DART SERVICE INSTRUCTION

TO AMEND INSTALLATION INSTRUCTIONS D350-607-3 Rev.D,
INSTALLATION INSTRUCTIONS D350-607-4 Rev. C AND
INSTRUCTIONS FOR CONTINUED AIRWORTHINESS ICA-D350-607 REV. 6
REF TCCA STC: SH94-14
REF FAA STC: SR00213NY
REF EASA STC: EASA.10016996
REF BRAZILIAN STC: 2007S03-03/-04/-05/-06

A	NEW ISSUE	AJS	14.05.16
REV.	DESCRIPTION	BY	DATE
DESIGN	AJS	DART AEROSPACE LTD HAWKESBURY, ONTARIO, CANADA	
DRAWN	AJS		
CHECKED	N/A	DRAWING NO.	REV. A
MFG. APPR.		DSI 9699	SHEET 1 OF 2
APPROVED		TITLE	SCALE
DE APPR.		LUG REPLACEMENT	NTS
DATE	14.05.16	COPYRIGHT © 2014 BY DART AEROSPACE LTD THIS DOCUMENT IS PRIVATE AND CONFIDENTIAL AND IS SUPPLIED ON THE EXPRESS CONDITION THAT IT IS NOT TO BE USED FOR ANY PURPOSE OR COPIED OR COMMUNICATED TO ANY OTHER PERSON WITHOUT WRITTEN PERMISSION FROM DART AEROSPACE LTD.

FIGURE 1: INSTALLATION OF D4775-041 FWD STRUT

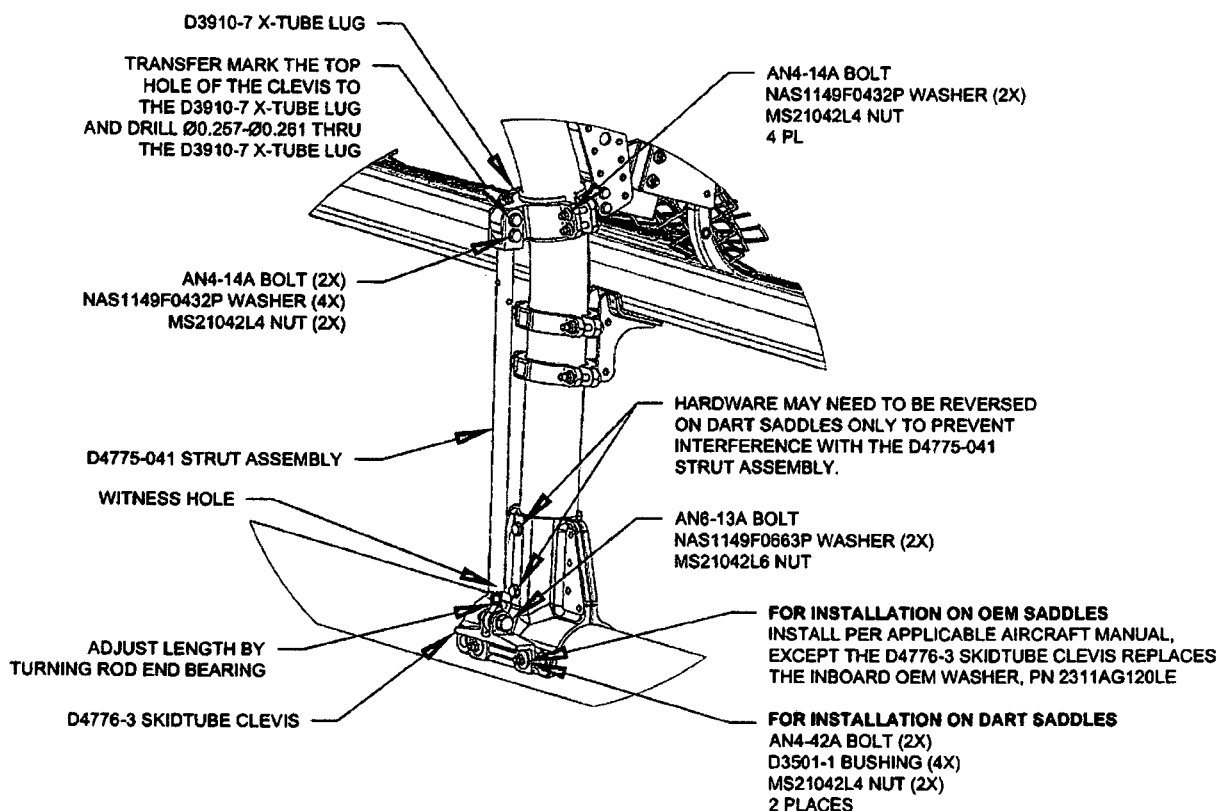
- 3.1 Substitute the Forward Lower D3910-5 X-Tube Lug with the D3910-7 X-Tube Lug as shown in Figure 1.
- 3.2 Install the forward D4775-041 Strut Assembly. Transfer mark from the upper hole on the clevis of the D4775-041 Strut Assembly to the D3910-7 X-tube Lug and drill thru the lug $\varnothing 0.257$ - $\varnothing 0.261$ as shown in Figure 1. Touch up chemical conversion coating per MIL-DTL-5541. Check the witness holes located at the bottom end of the D4775-041 Strut Assemblies to ensure that the thread from the rod end extends past the witness hole.
Torque MS21042L4/-4 nuts to 50-70 in-lbs (5.7-7.9 N-m). Torque MS21042L6/-6 nuts to 160-190 in-lbs (18.1-21.5 N-m).
- 3.3 Complete the installation in accordance with Installation Instructions D350-607-3 Rev. D or D350-607-4 Rev. C.
